**Application For Reissue of
U.S. Patent No. 6,000,374**

For: MULTI-CYCLE, ENGINE BRAKING WITH POSITIVE POWER VALVE
ACTUATION CONTROL SYSTEM AND PROCESS FOR USING THE
SAME

Preliminary Amendment in Reissue Application

Request for Approval of Drawing Changes

FIG. 3

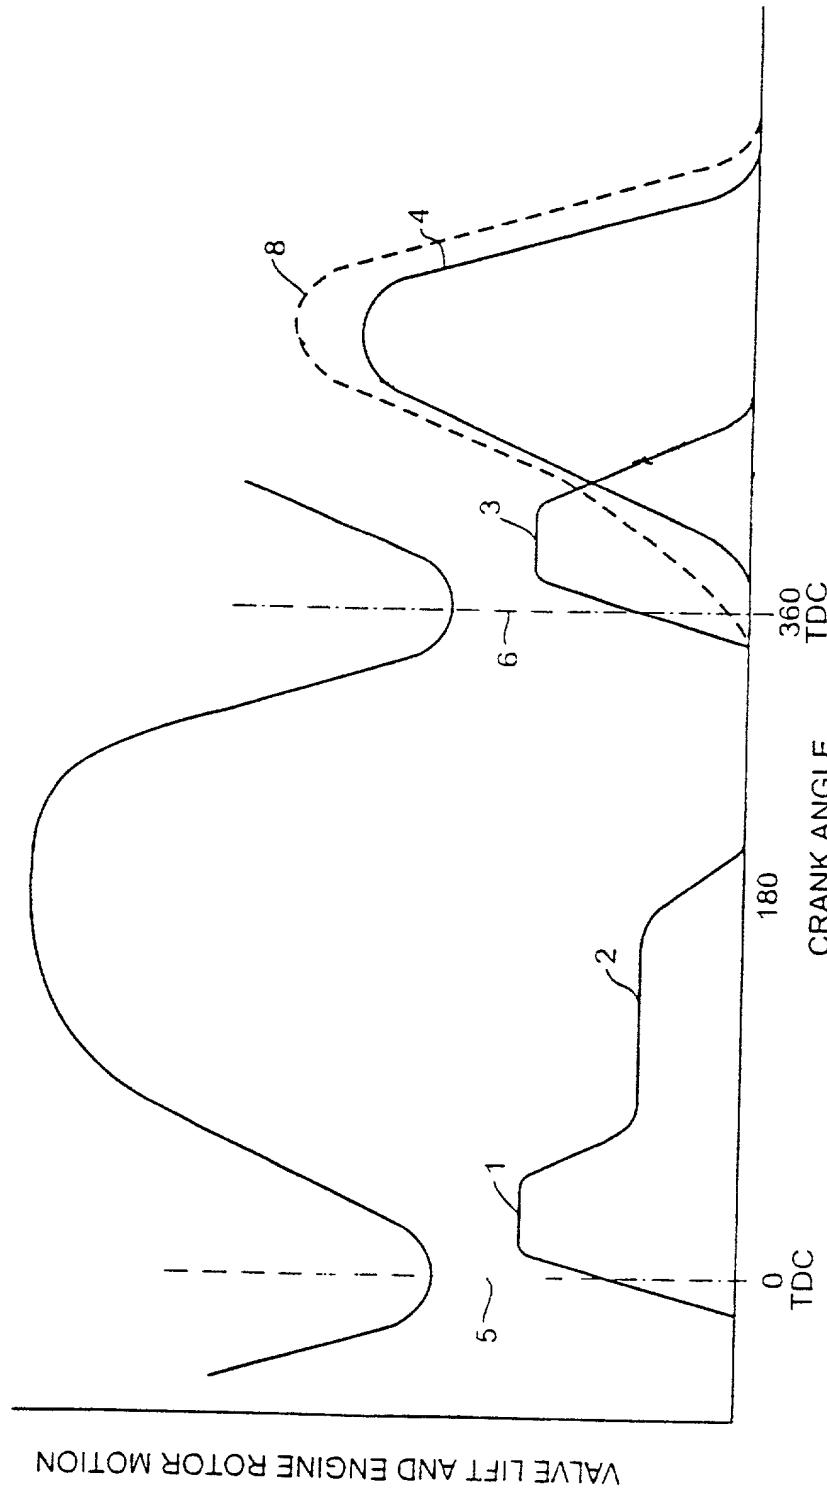
The brake cam lobe 23 includes a first compression release lobe. In a preferred embodiment, as shown in Fig. 3, the [profile of the lobe starts at about 35°. The] first compression release [lobe] event 1 is timed to start at about 40° before compression top dead center (TDC), then reach maximum opening around compression top dead center.

The first compression release event is timed to then [Then] start closing after compression top dead center, staying partially open for a period, as shown by the exhaust gas recirculation event 2, and then closing around bottom dead center[,]. [and finish just after compression TDC.] A second [lobe] compression release event 3 is timed to start about [1000] 40° before exhaust TDC [after compression TDC] and finish by [200°] 70° after [compression] exhaust TDC.

Fig. 3 depicts the exhaust valve opening and remaining open for optimum engine braking. As shown in Fig. 3, the motion begins [at the] before the TDC of the first compression stroke. Additionally, the extended plateaus shown during which the exhaust valve remains open but with a reduced valve opening, permits drawing exhaust

FIG. 4

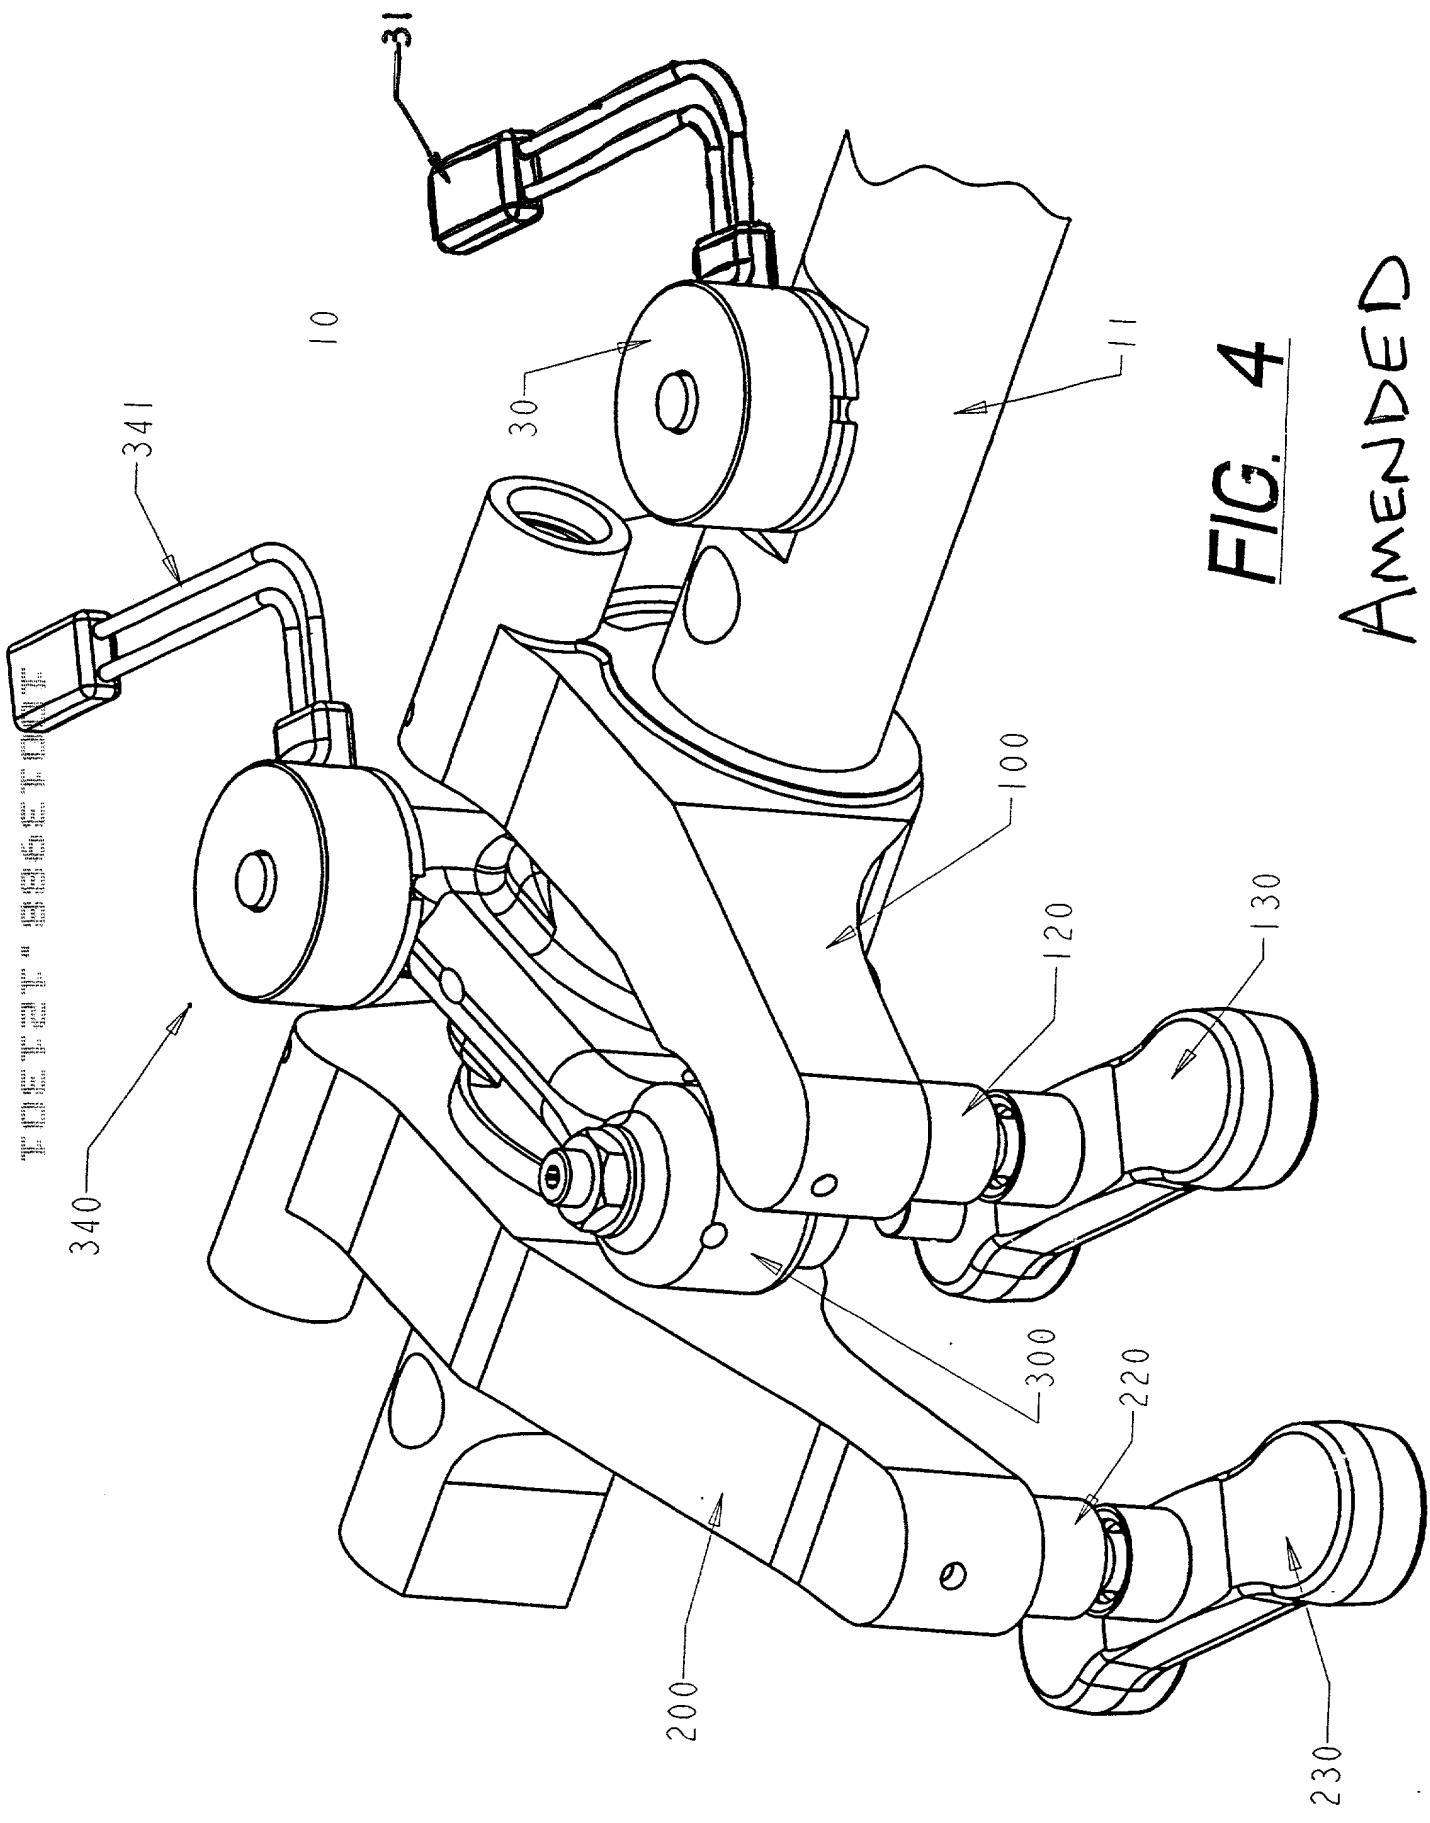
Fig. 4 is a plan schematic view illustrating the [dual cam] rocker arm arrangement and dedicated brake rocker for a compression release-type engine brake according to the present invention;

Reference will now be made in detail to a preferred embodiment of the present invention, an example of which is illustrated in the accompanying drawings. Fig. 4 and Fig. 18 illustrate a schematic view of the valve side of [dual cam shaft] a rocker arm arrangement and dedicated brake cam rocker for a compression release-type engine brake assembly **10** according to the present invention. The compression release engine brake components and the valve actuation components are located in rocker arms **100, 200, and 300**.

FIG. 6
AMENDED

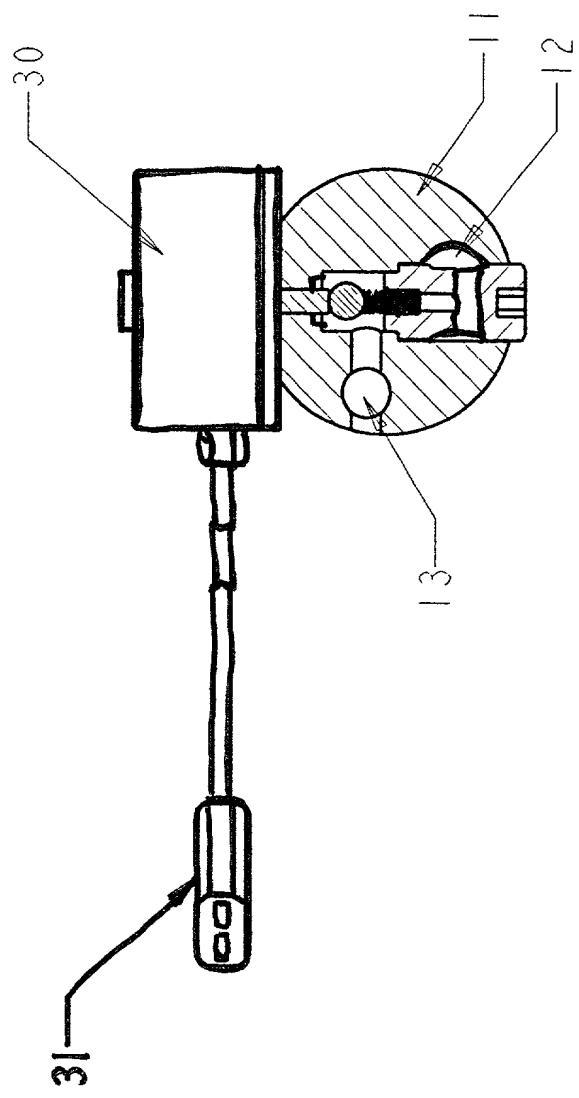
Fig. 6 is a cross-sectional view of [the exhaust] a common rocker shaft [of Fig. 5 along section line I-I] and a solenoid valve according to one embodiment of the present invention;

FIG. 7

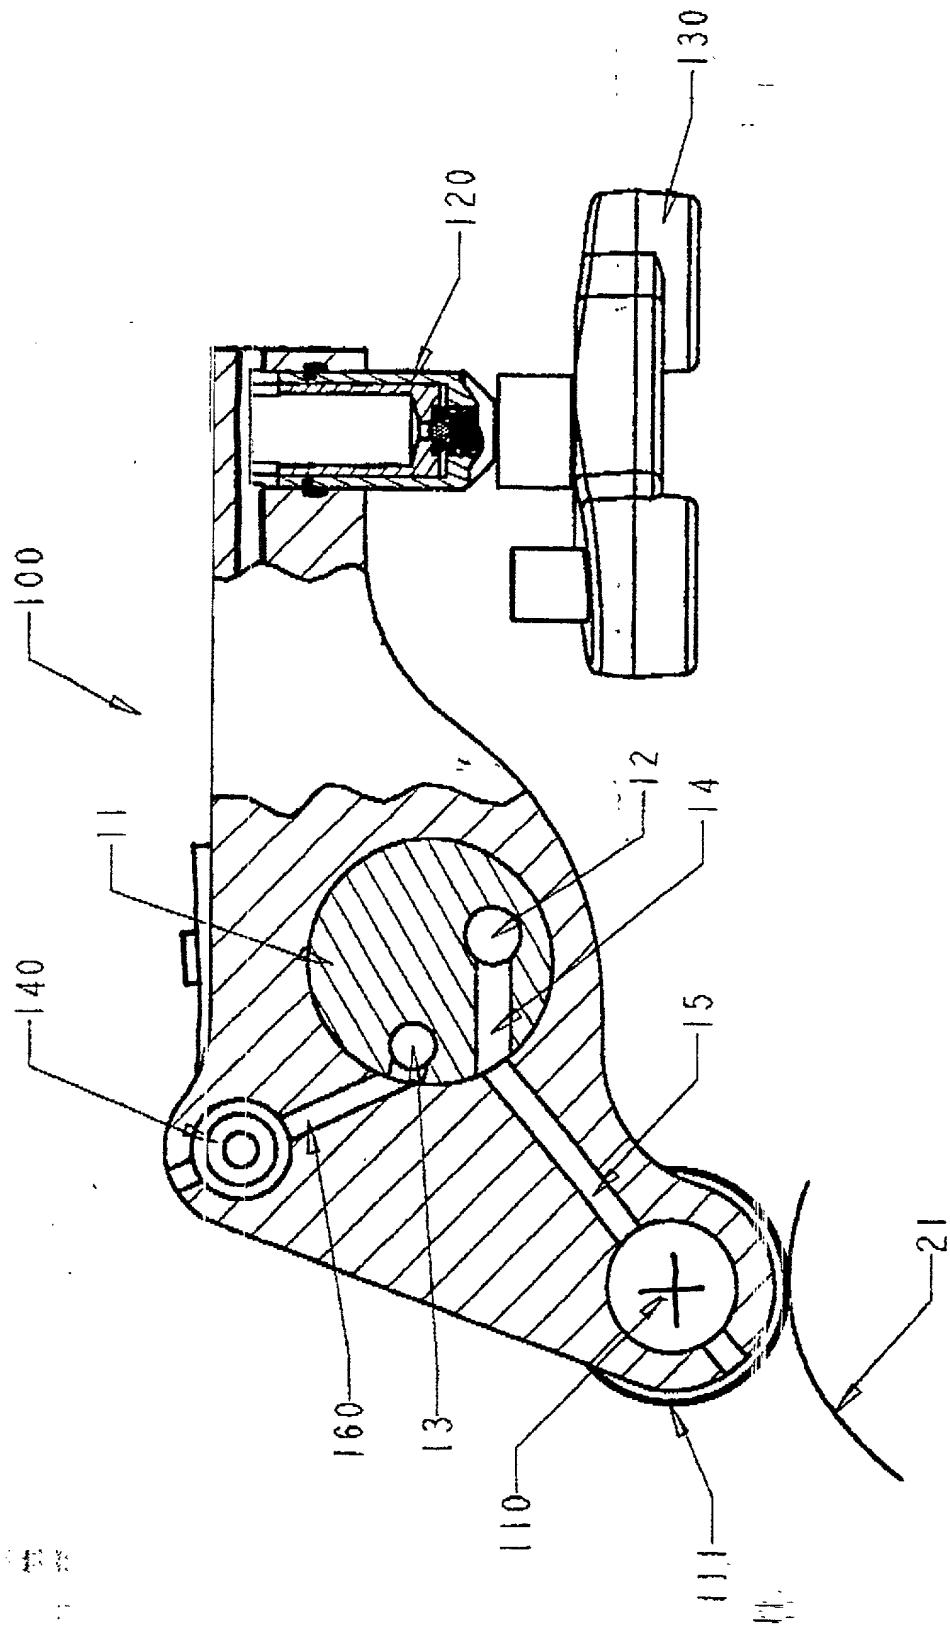
Fig. 7 is a partial cross-sectional view of [the] an exhaust rocker arm [of Fig. 5 along section lines II-II and III-III] according to one embodiment of the present invention;

communication with a fluid passageway 160 that extends between the control valve 140 and supply passage 13 of the common rocker shaft 11, as shown in Fig. 7.

FIG. 8

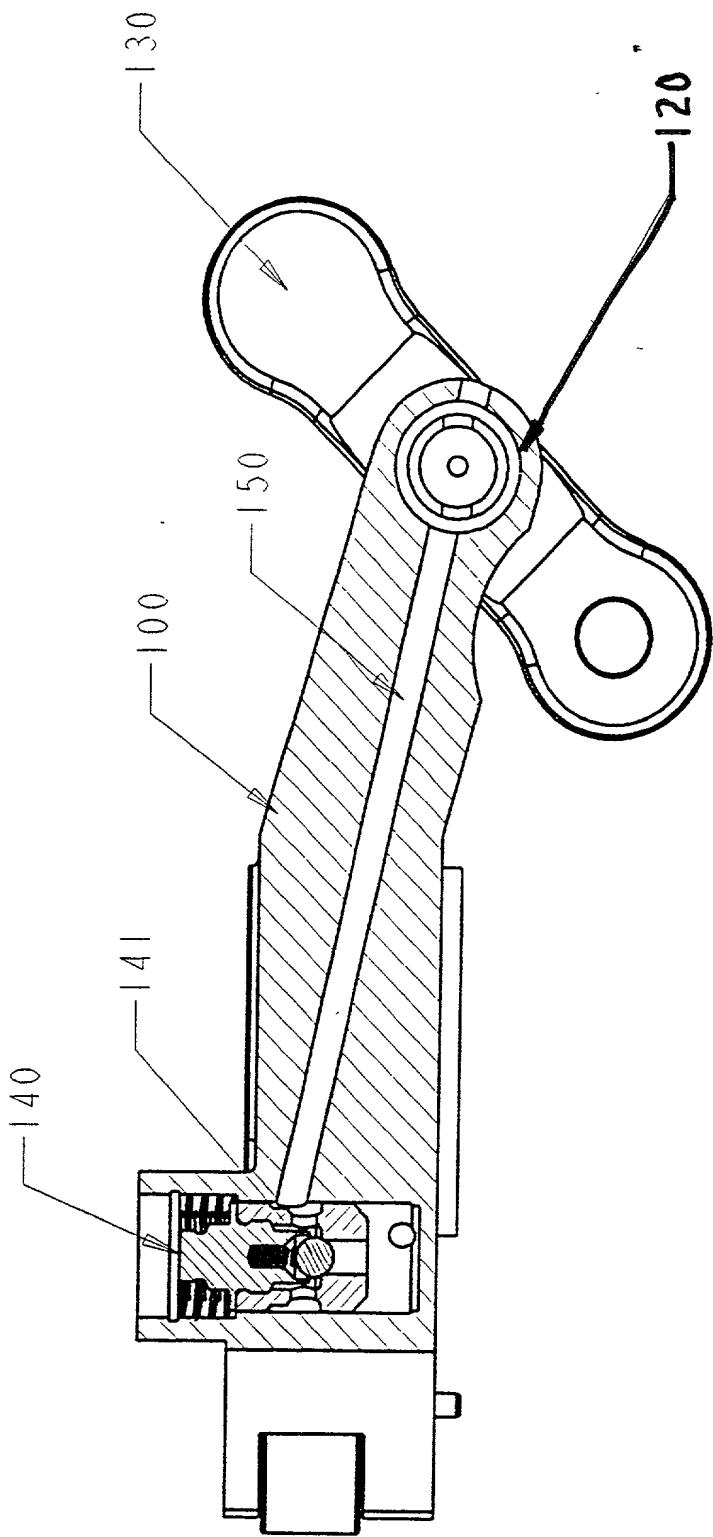
Fig. 8 is [a partial cross-sectional] an overhead view of [the] an exhaust rocker arm [of Fig. 7 along section line IV-IV] according to one embodiment of the present invention;

Means for effecting exhaust valve operation will now be described in connection with Figs. [5-9] 7 and 8. The means includes an exhaust rocker arm **100** that is rotatably mounted on the common rocker shaft **11**. A first end of the exhaust rocker arm **100** includes an exhaust cam lobe follower **110**. The exhaust cam lobe follower **110** preferably includes a roller follower **111** that is in contact with the exhaust cam lobe **21**.

FIG. 11
AMENDED

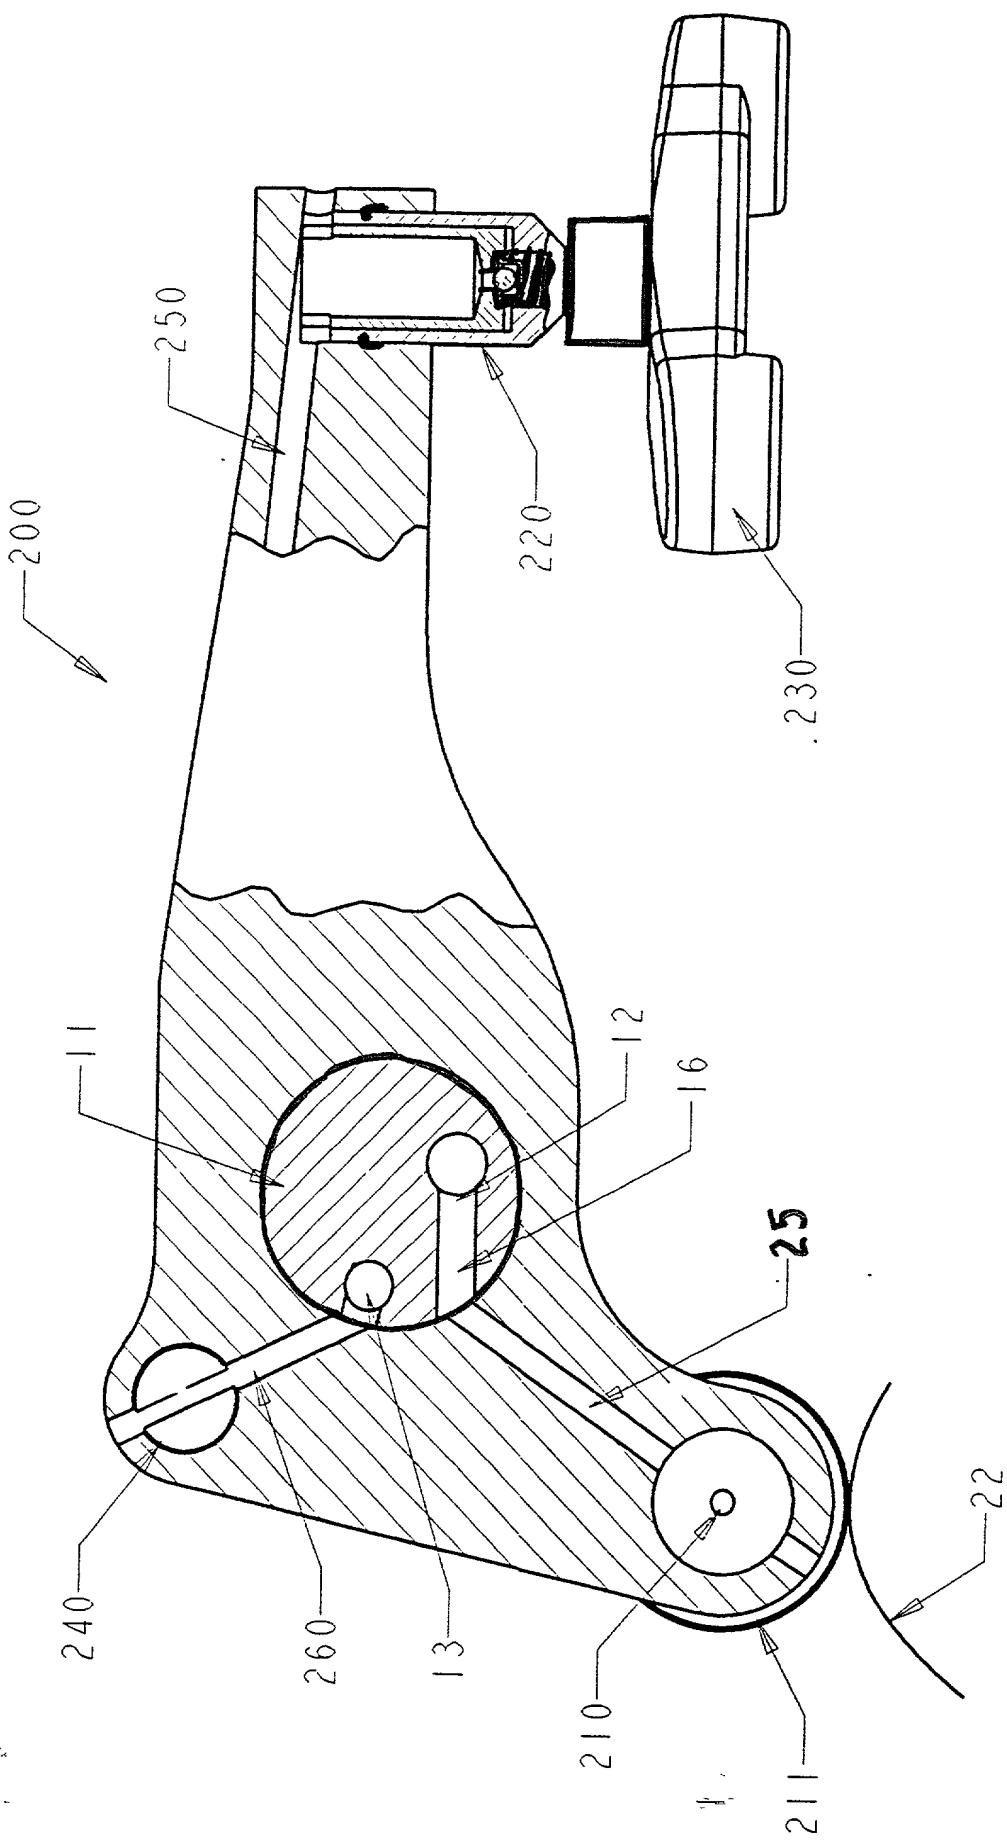
Fig. 11 is a partial cross-sectional view of [the] an intake rocker arm [of Fig. 10 along section lines V-V and VI-VI] according to one embodiment of the present invention;

is also preferably a bridge device that is capable of opening two intake valves simultaneously. The intake rocker arm 200 also includes a control valve 240. The control valve 240 is in communication with a fluid passageway 250 that extends through the exhaust rocker arm 200 to the lash adjuster 220, as shown in Fig. 12. The control valve 240 has the same construction as the control valve 140 described above in connection with the exhaust rocker arm 100. The control valve 240 is also in communication with a fluid passageway 260 that extends between the control valve 240 and supply passage 13 of the common rocker shaft 11, as shown in Fig. 11.
